From: Perry, Russell <rperry@usgs.gov>
Sent: Friday, May 24, 2019 8:30 AM
To: Micko, Steve/SAC
Cc: Vamsi Sridharan - NOAA Affiliate; Cathy Marcinkevage - NOAA Federal; Adam Pope; J Stuart; Leaf, Rob/SAC; Sumer, Derya
Subject: Re: [EXTERNAL] Re: Preliminary ROC on LTO plots to start discussion

From: Perry, Russell <rperry@usgs.gov>
Sent: Thursday, May 23, 2019 11:35 AM
To: Vamsi Sridharan - NOAA Affiliate <vamsi.sridharan@noaa.gov>; Micko, Steve/SAC <Steve.Micko@jacobs.com>
Cc: Cathy Marcinkevage - NOAA Federal <cathy.marcinkevage@noaa.gov>; Adam Pope <apope@usgs.gov>; J Stuart <J.Stuart@noaa.gov>
Subject: Re: [EXTERNAL] Re: Preliminary ROC on LTO plots to start discussion

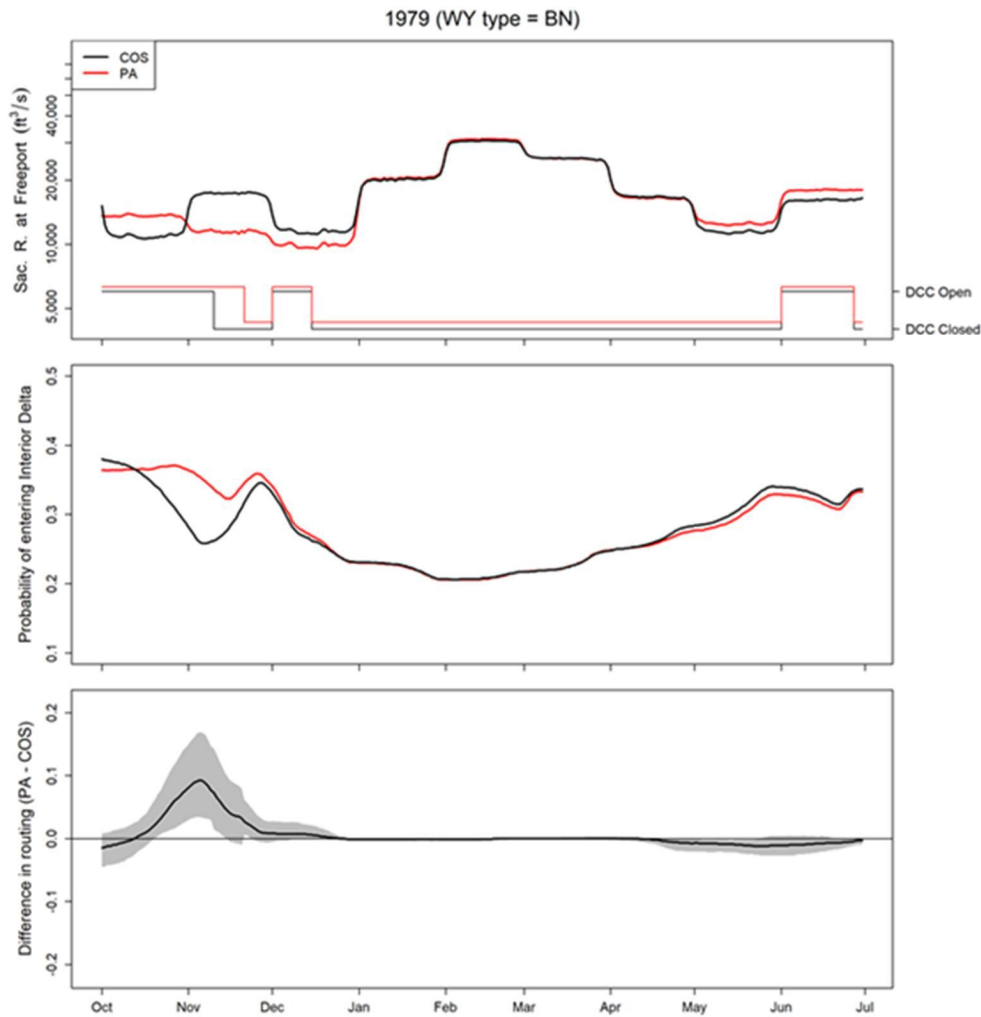
Got it. So I imagine CalSimm II is modeling how many days in a month the DCC will be open, and in DSM2, it will open from the first day of the month up the number of days indicated from the CalSim II output. Is that correct?

Thanks for the help in understanding how daily flows were constructed from the monthly flows. I have another question about DCC operations to help us interpret our results. In October/November we are finding some differences in DCC operation between scenarios in some years (see top panel below). Can you tell us the control rule that is causing there to be different DCC operations between scenarios? It doesn't appear to be flows > 25 kcfs, which triggers a DCC closure.

CalSim II develops the DCC operation schedule. Although there is a proposed change to DCC operations, model representation of the proposed DCC operations are the same in COS and PA. Proposed changes cannot be captured within the CalSim model.

I believe the CalSim II implementation of October 1 – December 14 period in NMFS BO Action 4.1.2 causes different DCC operations between COS and PA. In the PA, CalSim II opens DCC gates for more days in October/November (depending on the year) to meet water quality standards at Jersey Point and Rock Slough.
